UNITED STATES
NUCLEAR REGULATORY COMMISSION
WASHINGTON, D.C. 20555-0001

SUBJECT: BRUNSWICK STEAM ELECTRIC PLANT, UNITS 1 AND 2 – ISSUANCE
OF AMENDMENT NOS. 299 AND 327 TO REVISE TECHNICAL
SPECIFICATION 5.6.5b TO ALLOW APPLICATION OF ADVANCED
FRAMATOME ATRIUM 11 FUEL METHODOLOGIES (EPID L-2018-LLA-0273)

BRUNSWICK STEAM ELECTRIC PLANT, UNITS 1 AND 2

Figure 13: Reference Case Peak Cladding Temperature During TTWB ATWS-I

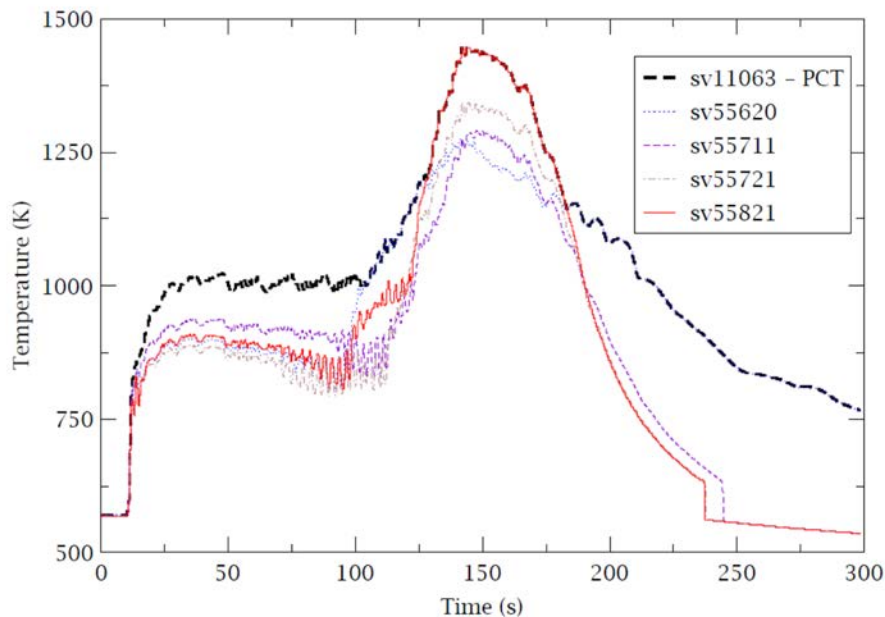
The PCT occurs in channel 821. Channel 821 is located in a region of the core with strong first harmonic flux peaking and could be expected to experience strong oscillations when the regional mode is excited. The NRC staff notes that the flow rates in Figure 10 and Figure 11 above are not the channel inlet flows. Rather, they represent the channel flows downstream of the water rod inlet holes. Therefore, because these flows are tracked at a higher axial elevation in the bundle, they underreport the magnitude of the flow oscillation experienced at the channel inlet. As a result, the NRC staff cannot directly compare the active flow predicted by TRACE with the channel inlet flow reported by the licensee. The channel inlet flow oscillation reported by the licensee (for the same downstream flow oscillation) will be of a higher magnitude due to flow incompressibility at the channel inlet. These plots are presented primarily to illustrate that the core becomes unstable in the out-of-phase mode and that the peak harmonic flux channel experiences large-amplitude flow oscillations.

TRACE predicts that the fuel goes into dryout during the initial flow reduction following the recirculation pump trip and that some of the fuel rods start to heatup. However, the highest temperatures occur later in the event once the reactor becomes unstable. Figure 13 shows the PCT, as well as the hottest cladding surface temperatures for candidate hot assemblies. The PCT represents the hottest cladding surface temperature anywhere in the core at any instant and does not represent a temperature history for any given location or specific bundle. The PCT plot is shown alongside plots of the peak cladding temperature for the hottest fuel rod within selected fuel assemblies. The figure shows that while channel 821 (depicted by the sv55821 curve) yields the highest overall PCT, the cladding in channel 821 does not experience as significant of a heatup until the reactor becomes unstable.

Figure 14: Example Power/Flow Operating Map for Brunswick

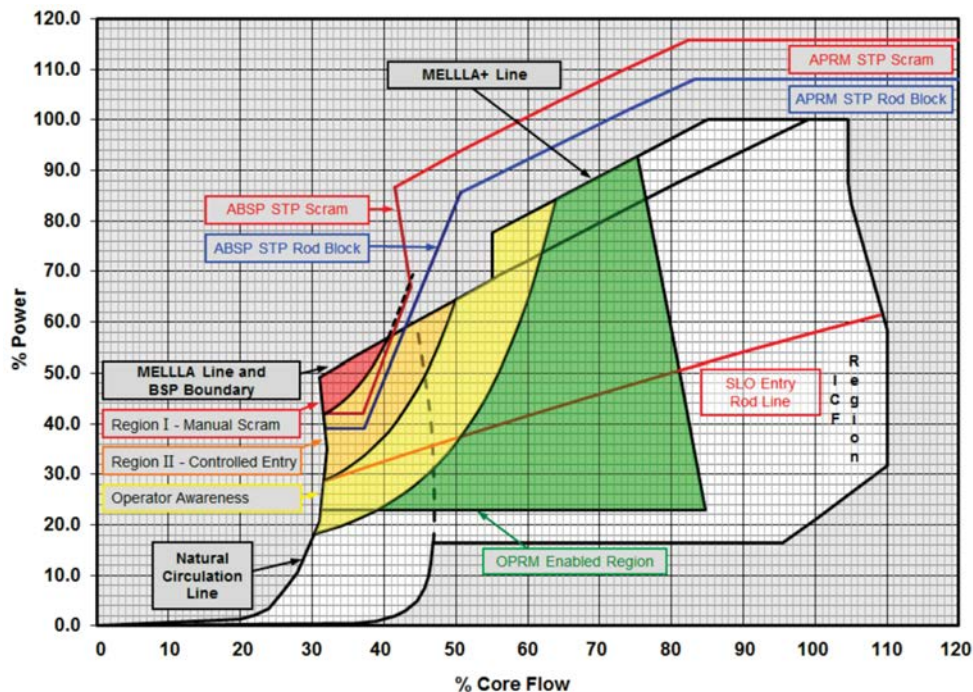
The licensee identified a 2RPT from the minimum flow condition at rated power within the MELLLA+™ operating domain to be the limiting event for LTSS. This limiting event identification is consistent with previous plant-specific applications of Option III and EO-III. Pump trip events may lead to instability due to a large reduction in core flow rate combined with a relatively modest reduction in power, which moves the core toward the upper left corner of the power-flow operating map, an example of which is depicted in Figure 14. These conditions promote unstable oscillations.

In particular, the 2RPT event from the lowest flow at rated power is expected to be the most limiting pump trip event because it starts from operation at the highest control rod line, which results in the highest power level, and therefore, most unstable condition following the recirculation pump trip.
